Subject: Amendment to USNRC License 12-16356-01E to permit distribution of modified Type 500 Ionization Smoke Detector Assembly.

The modified design is to be designated Type 500A.

Enclosure 1 shows the parts and assembly as presently licensed. Enclosure 2 shows the same parts and assembly with the desired revisions. The drawings are:

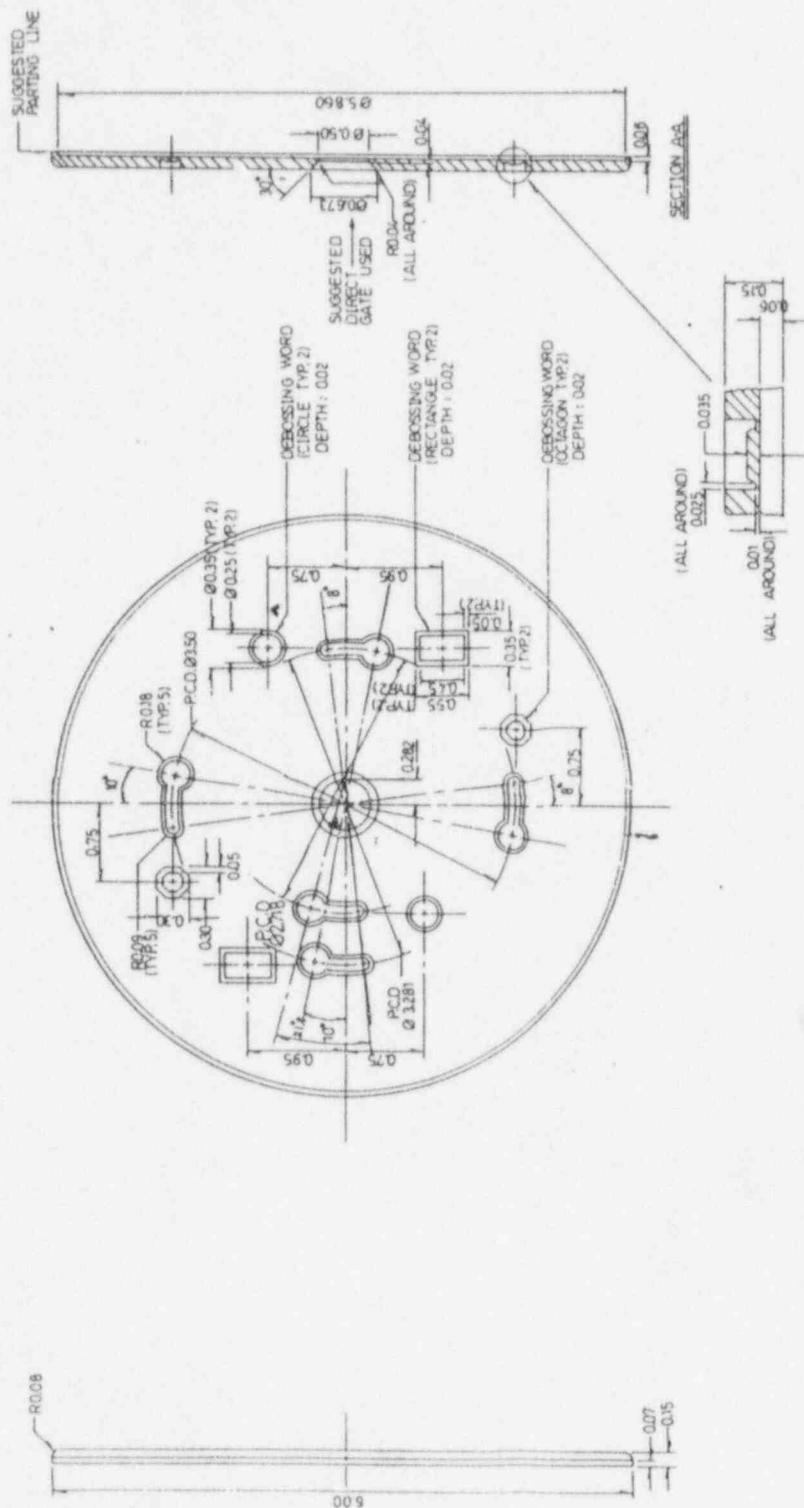
1. Ionization Smoke Detector Assembly (Drawing No. 1)
The method of holding together the assembly is changed from four 4-40 screws to two 4-40 screws and two 1/8" diameter rivets. These rivets are made of nylon coated aluminum. The change is to keep the chamber together during subsequent assembly operations of the entire smoke detector. In addition it renders the assembly more tamper-proof.
2. Sense Chamber (Drawing No. 2)
Change the diameter of two of the holes in the edge from 0.162" to 0.128" for the rivets.
3. Reference Chamber (Drawing No. 3)
Change the diameter of two of the holes in the edge from 0.162" to 0.128" for the rivets.

4. Chamber Insulator (Drawing No. 4)
Change shape as shown to provide registration of the part for automatic assembly.
5. Top Collector (Drawing No. 5)
Remove material along chord to provide registration of the part for automatic assembly.
6. Bottom Collector (Drawing No. 6)
No change
